Wrong installing points for the MIB STD2 PQ of UA guide

► Step 4: Solder wires to the Panel PCB.

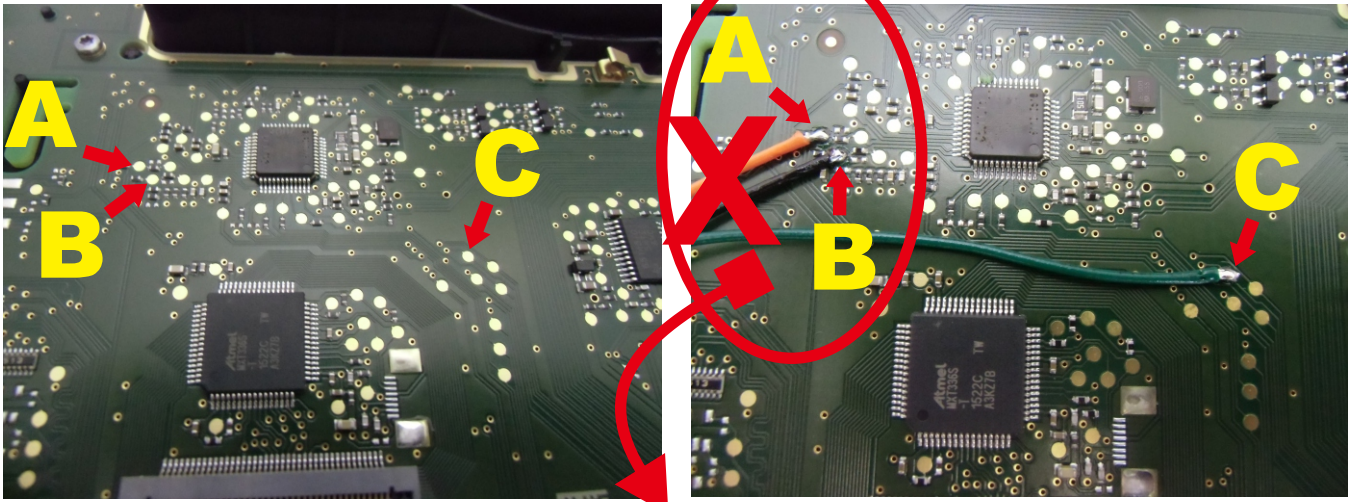
Solder the PQ-W1 wire of black wire to A point, orange wire to B point, green wire to C point on the Panel PCB.

Sorry,,,,,We have found a wrong directing point in our MIB STD2 PQ of UA guide,,,,,

Please study the photo image above,,,,,,Please exchange the **orange wire** and the Black wire of soldering,,,,,,then, the touch function would be OK,

Please do the modification as mentioned and test the MIB STD2 PQ interface again.....
